UNITED STATES PATENT AND TRADEMARK OFFICE

APPLICATION NO.	FILING DATE	FIRST NAMED INVENTOR	ATTORNEY DOCKET NO.	CONFIRMATION NO.
10/687,993	10/20/2003	Ok Byung Kim	1514.1031	1374
49455	7590	04/18/2006	EXAMINER	
STEIN, MCEWEN & BUI, LLP 1400 EYE STREET, NW SUITE 300 WASHINGTON, DC 20005			RIELLEY, ELIZABETH A	
			ART UNIT	PAPER NUMBER
			2879

Office Action Summary

DETAILED ACTION

FIG. 44

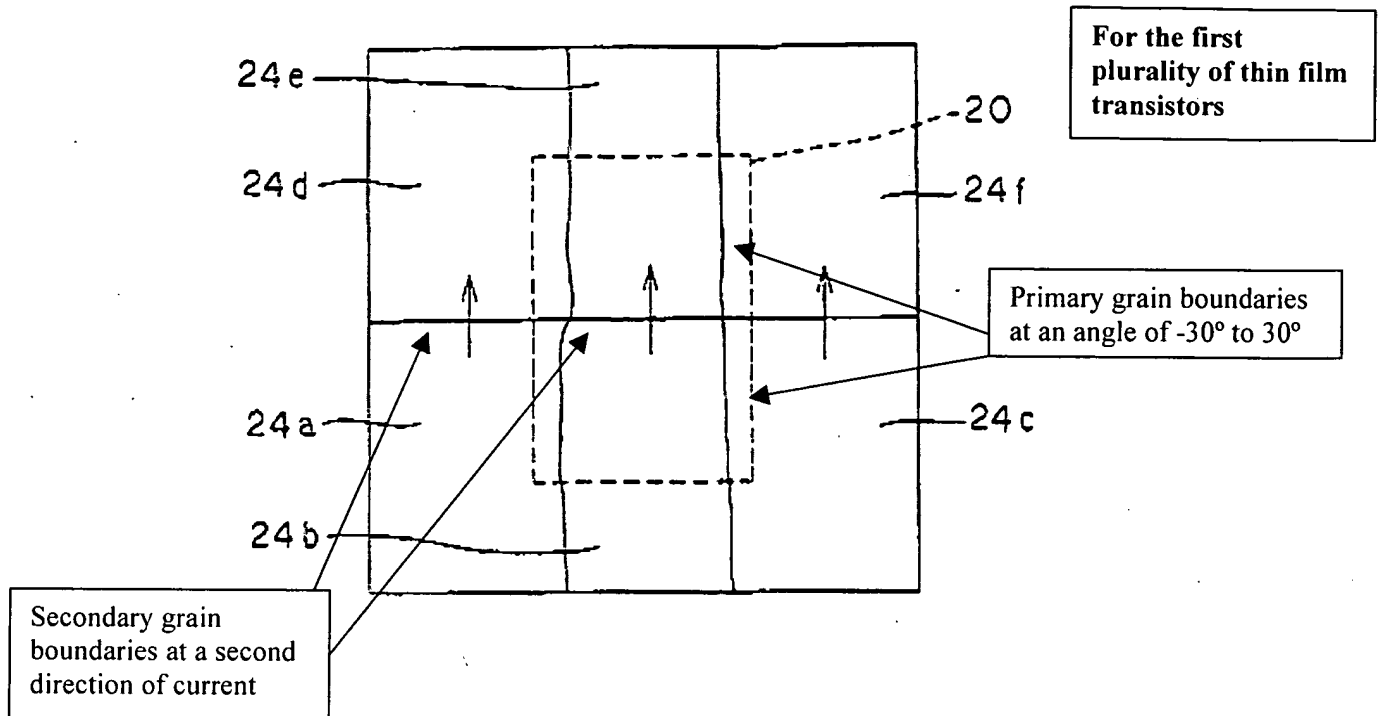
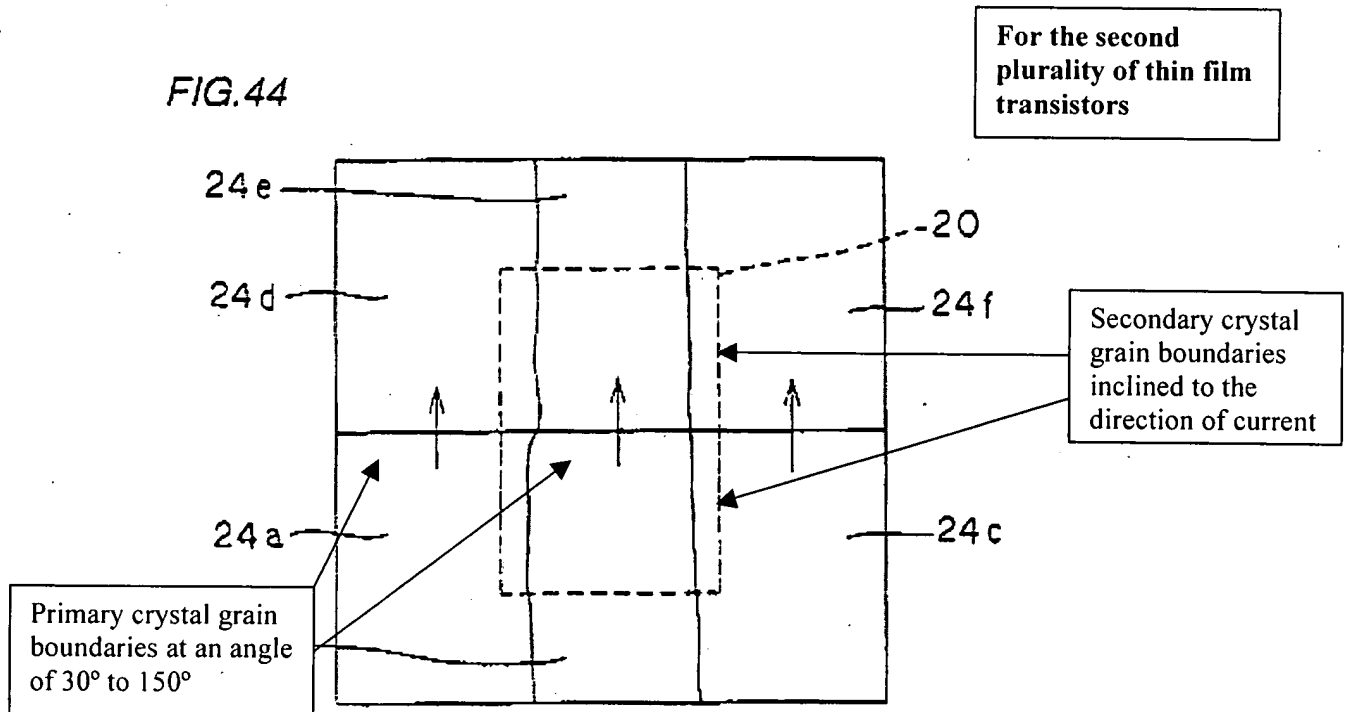
In regard to claim 1, Mitnaga et al ('997) teach a display device with a polysilicon substrate (250; figures 3b and 5a; column 13 line 47 to column 14 line 55), comprising: a display region (PTFT, 111, 133; figure 2; column 13 line 11-column 14 line 55) and a driving region (NTFT; figure 2; column 13 line 11 – column 14 line 55; claims 10-15); a first plurality of thin film transistors in the display region (PTFT; figure 2); a second plurality of thin film transistors (NTFT) and primary crystal grain boundaries (216; figure 5B; column 14 lines 55-65) in the polysilicon substrate in the display region and in the driving region (claim 10); secondary crystal grain boundaries in the polysilicon substrate in the display region and the driving region (claim 10 states that both active regions have at least one grain boundary, claims 13

and 14 teach that the TFTs are used for both a display region and a driver region); wherein the primary crystal grain boundaries are inclined to a first direction of current flowing from source (208) to drain (210) of each of the first plurality of thin film transistors at an angle of -30° to 30° (figure 5b; column 14 line 56 to column 15 line 4; claim 10, the grain boundaries of the first active region are parallel to the direction of current, thereby making that angle 0°); and wherein the primary crystal grain boundaries are inclined to a second direction of current flowing from source to drain of each of the second plurality of thin film transistors at an angle of 30° to 150° (claim 10; lines 47-column 16 line 17; claim 10 states that the crystal grain boundaries in the second region are perpendicular to the second current in the second TFT – the first current being in the first TFT – these primary crystal grain boundaries in the second region being perpendicular to the current would then be at an angle of 90°). Mitnaga et al ('997) are silent regarding the limitations of the secondary crystal grain boundaries are inclined to a second direction of current flowing from source to drain of each of the first plurality of thin film transistors, and the secondary crystal grain boundaries are inclined to the first direction of the current flowing from source to drain of each of the second plurality of thin film transistors. However, one skilled in the art would reasonably contemplate modifying the device of Mitnaga et al ('997) to include the claimed secondary crystal grain boundaries are inclined to a second direction of current flowing from source to drain of each of the first plurality of thin film transistors, and the secondary crystal grain boundaries are inclined to the first direction of the current flowing from source to drain of each of the second plurality of thin film transistors, as an obvious matter of design engineering as evidenced by Shimizu et al ('146). Shimizu et al teach crystal grain boundaries perpendicular to other crystal grain boundaries in many different ways, and Shimizu does not make a distinction between primary and secondary boundaries (column 1 lines 21-42; column 12 line 35 to column 13 line 4). Therefore figure 44 as described below teaches the claimed secondary boundaries (arrows indicate current flow).

Applicant's claimed material does not provide unexpected results that are not within the teaching applied, since both grain boundaries disclosed in Mitnaga and Shimizu as well as the grain boundaries disclosed by the Applicant perform the same function of improving the electrical characteristics of the polysilicon film. Thus, it would have been obvious at the time of the invention to one of ordinary skill in the art to combine the polysilicon film of Mitnaga et al ('997) with the secondary crystal grain boundary orientations as taught by Shimizu et al ('146). Motivation to combine would be to improve the electrical characteristics of the polysilicon film.

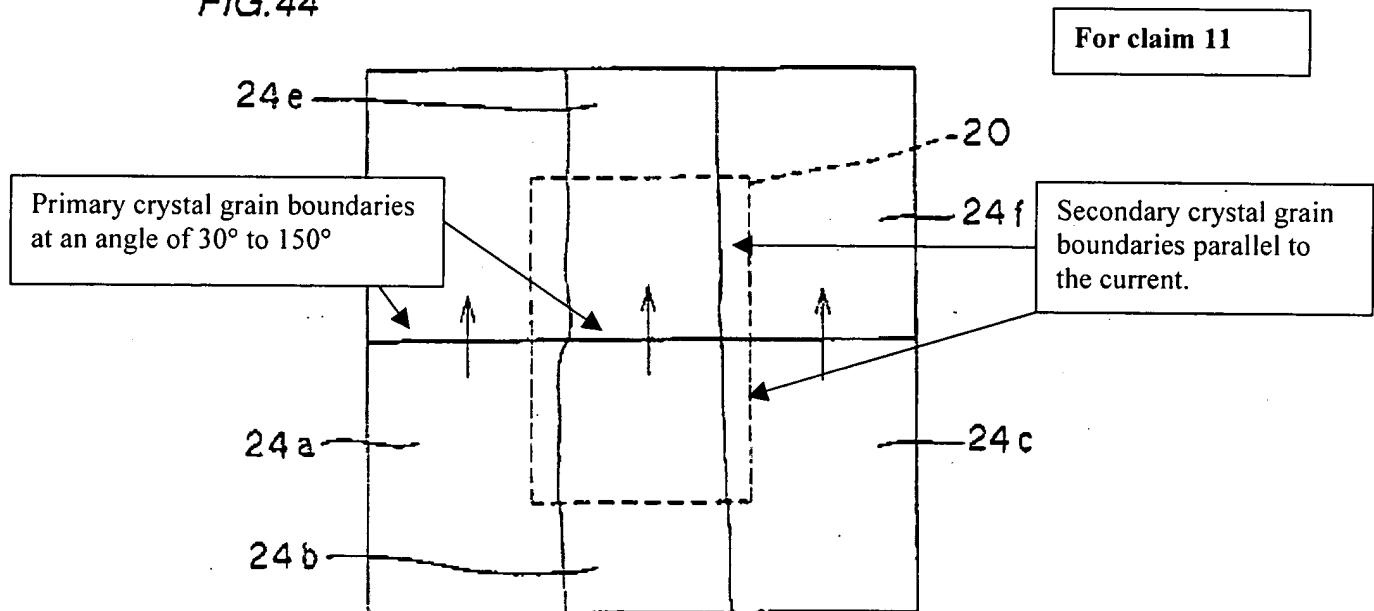
In regard to claim 7, Mitnaga et al ('997) teach the primary crystal grain boundaries are perpendicular to the second direction of current (column 15 line 48-column 16 line 18).

In regard to claim 8, Mitnaga et al ('997) teach second number of the primary crystal grain boundaries exist in active channel regions of each of the second plurality of thin film transistors (column 15 line 48-column 16 line 18).

FIG. 44

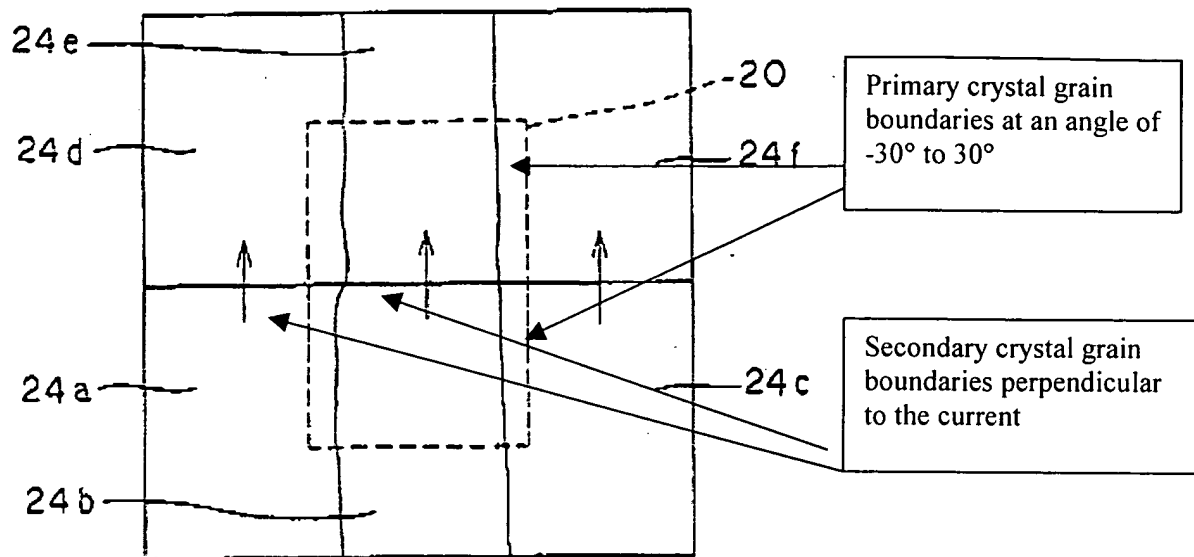
In regard to claim 11, Mitnaga et al ('997) teach a display device with a polysilicon substrate comprising: a driving region (claim 13); a plurality of thin film transistors in the driving region (claim 10); and primary crystal grain boundaries in the polysilicon substrate in the driving region (claim 10); and secondary primary crystal grain boundaries in the polysilicon substrate in the driving region (claim 10). Mitnaga et al are silent regarding the limitations of wherein the primary crystal grain boundaries are inclined to a direction of current flowing from source to drain of each of the plurality of thin film transistors at an angle of 30° to 150° and the secondary crystal grain boundaries are substantially parallel

to the current flowing from the source to the drain. However, one skilled in the art would reasonably contemplate modifying the device of Mitnaga et al ('997) to include the claimed crystal grain boundaries orientations as an obvious matter of design engineering as evidenced by Shimizu et al ('146). Shimizu et al teach crystal grain boundaries perpendicular to other crystal grain boundaries in many different ways, and Shimizu does not make a distinction between primary and secondary boundaries (column 1 lines 21-42; column 12 line 35 to column 13 line 4). Therefore figure 44 as described below teaches the claimed boundary orientations (arrows indicate current flow).

Applicant's claimed material does not provide unexpected results that are not within the teaching applied, since both grain boundaries disclosed in Mitnaga and Shimizu as well as the grain boundaries disclosed by the Applicant perform the same function of improving the electrical characteristics of the polysilicon film. Thus, it would have been obvious at the time of the invention to one of ordinary skill in

the art to combine the polysilicon film of Mitnaga et al ('997) with the crystal grain boundary orientations as taught by Shimizu et al ('146). Motivation to combine would be to improve the electrical characteristics of the polysilicon film.
